**SUBJECT: RECALL R14XF PASSENGER COMPARTMENT HEATER HOSE
FAILURE**

R14XF

**NHTSA RECALL NO. 14V-313 SCHOOL BUS
NHTSA RECALL NO. 14V-314 NON-SCHOOL BUS**

Coolant Thermostat and Passenger Compartment Heater Hose Replacement

Fig. 1

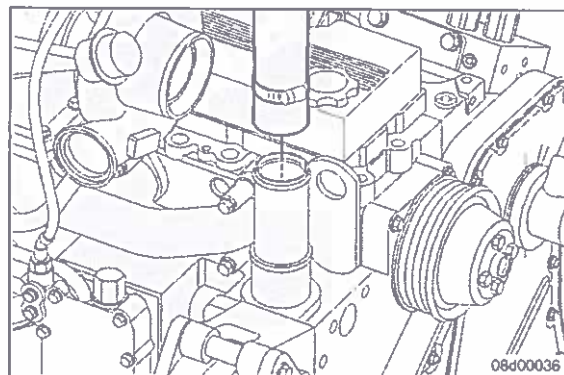
1. Park the bus on a level surface, apply parking brake, switch engine off, remove ignition key and chock wheels.
2. Disconnect batteries. (negative[-] cable first, then positive[+])
3. Drain the coolant per *Cooling System Drain, Flush & Refill* section in your Blue Bird service manual.
4. Remove the radiator hose from the water outlet connection. (Fig. 1)

Fig. 2

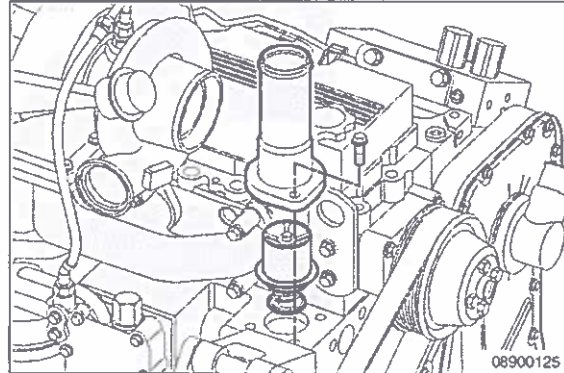
5. Remove the water outlet connection capscrews and water outlet connection. (Fig. 2)
6. Remove the thermostat and discard. (Fig. 2)

Fig. 3

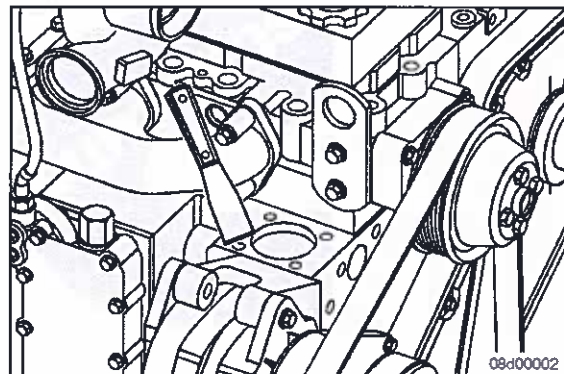
7. Clean all of the mating surfaces. (Fig 3)

NOTE: Do not let any debris fall into the thermostat cavity when cleaning the surfaces.

Fig. 4

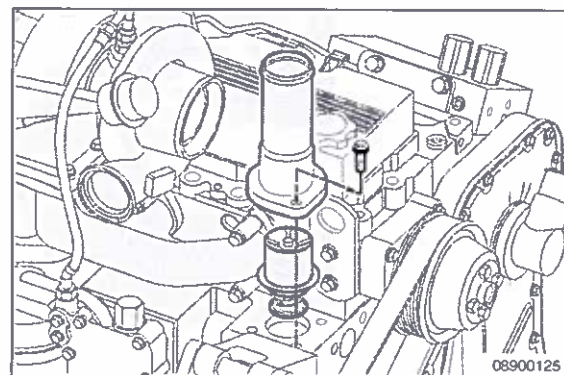
8. Install the new thermostat (BB# 10032468) into the water outlet connection. Make sure the top and bottom o-rings are in place. If the o-rings are damaged, replace with new o-rings. (Fig. 4)
9. Install the water outlet connection and mounting capscrews. (Fig. 4)
Torque Value: 24 nm [212 in-lb]

Fig. 5

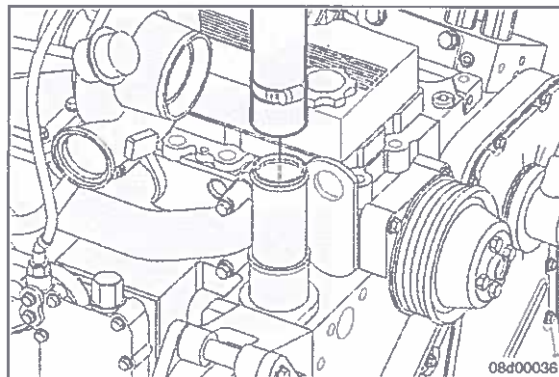
10. Install radiator hose on the water outlet connection. (Fig. 5)
Torque: 7.50 – 8.30 FT-LBS.
11. Thermostat replacement complete. Proceed to Heater Hose Replacement.

Fig. 1

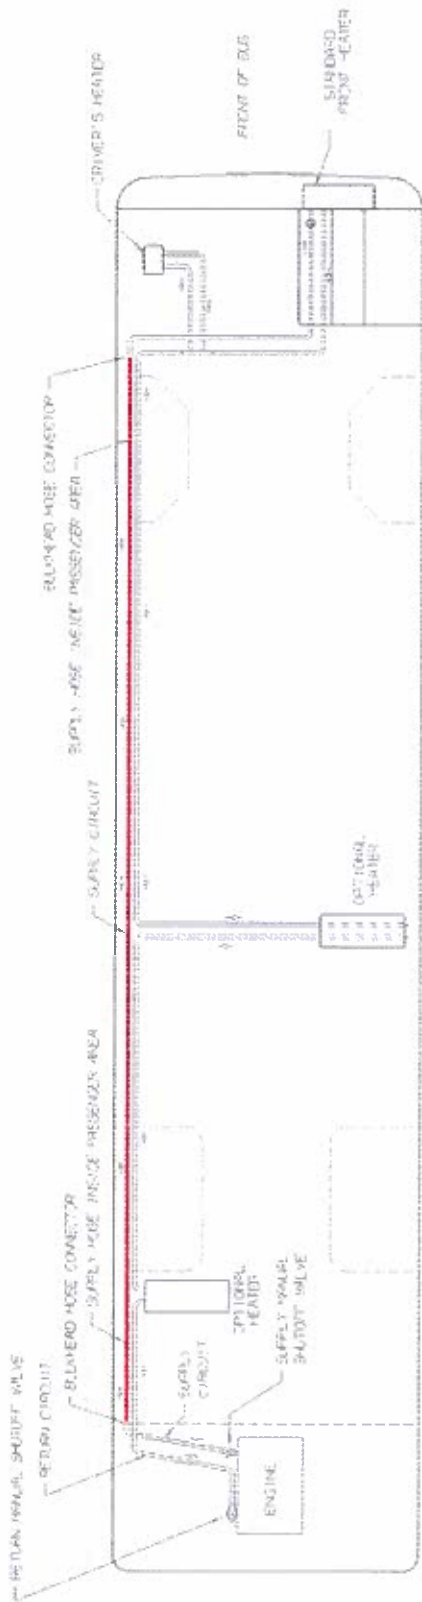
1. Check if heater supply/return hoses were connected to engine correctly per Fig 1 hose routing. *If hoses are not connected correctly at engine supply/return manual shutoff valves, replace only the section of hose inside bus from bulkhead connector to first heater. Disconnect/reconnect "supply/return" hoses in engine compartment per Fig 1 supply/return hose routing.*

2. Disconnect supply heaters coolant hose at engine cutoff valve (see Fig 1).
3. With 10 p.s.i. of shop air pressure, blow air through supply hose to remove coolant from heater system (see Fig 1 for location of supply hose in engine compartment).

4. Inside bus, remove heater hose covers to gain access to heaters supply hose.
5. Remove original heaters **supply** hose inside passenger compartment only and replace with new hose part no. 10023231 (see Fig 1). Torque all heater hose clamps to 34 inch lbs.

Fig. 2

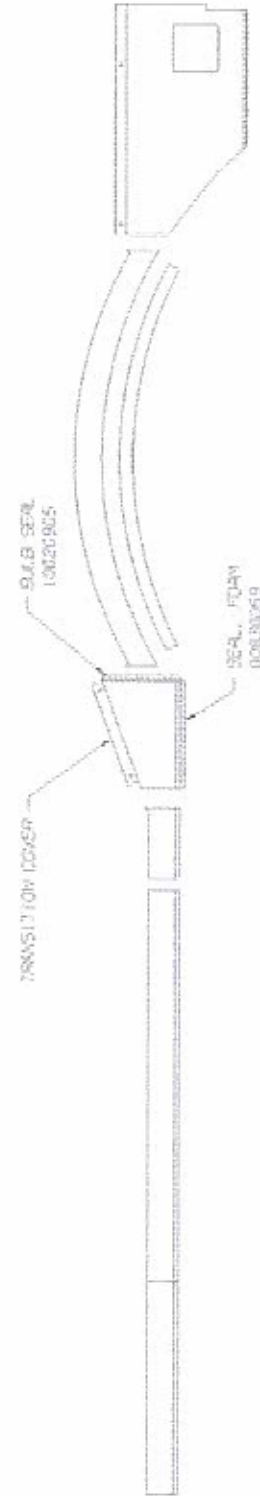
6. Reinstall passenger compartment heater hose covers. If gap is present at hose wheel housings **transition** covers, install bulb seal part no. 10020905 on end and foam tape part no. 00830059 on flange of transition cover to close out gaps per Fig 2.

Fig. 3

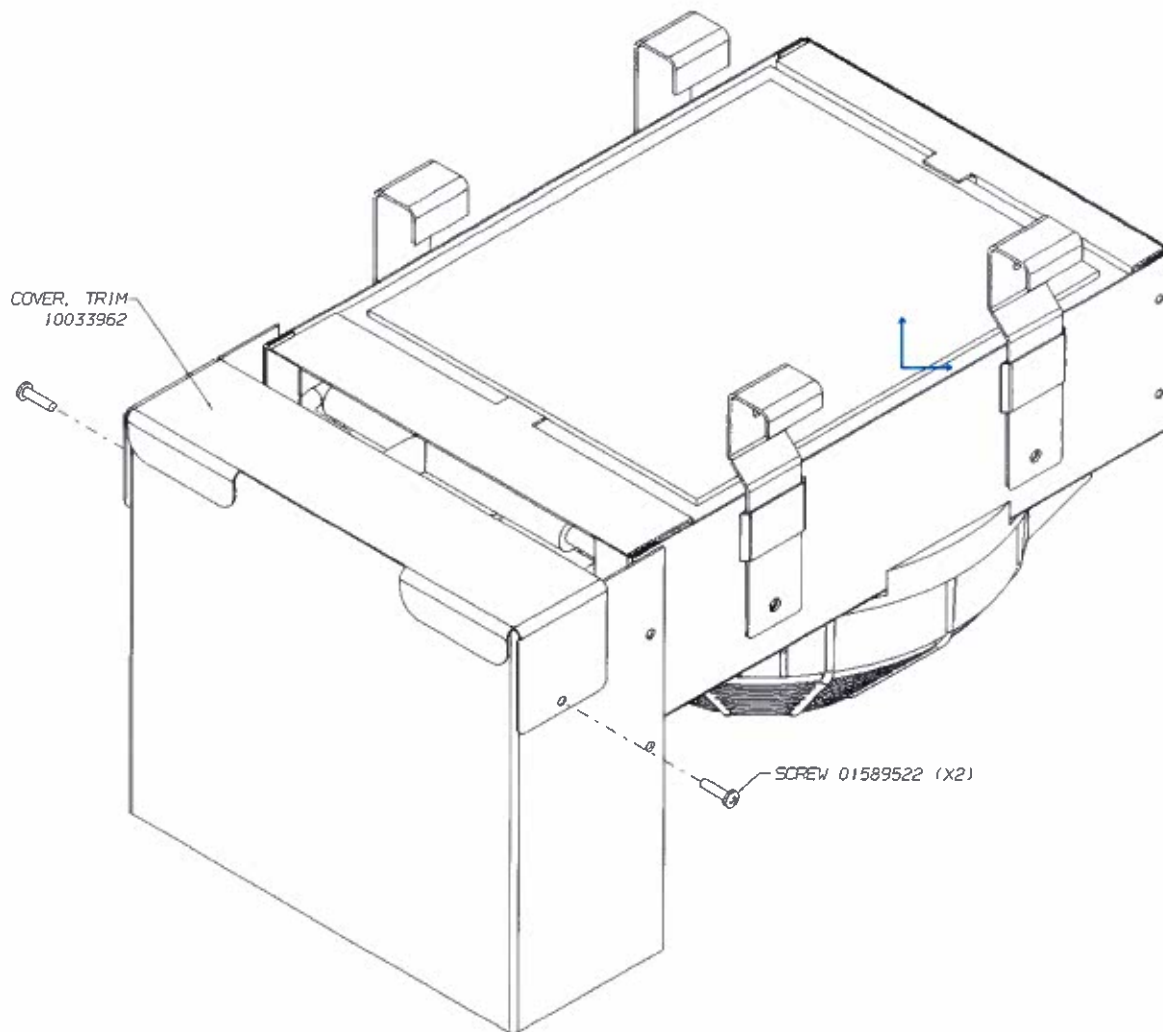
7. At each underseat heater, remove seat cushion and install heater pipe cover part no. 10033962. Back drill .056 hole on each side and attach cover with two #10 screws part no. 01589522 per Fig 3. Reinstall seat cushion
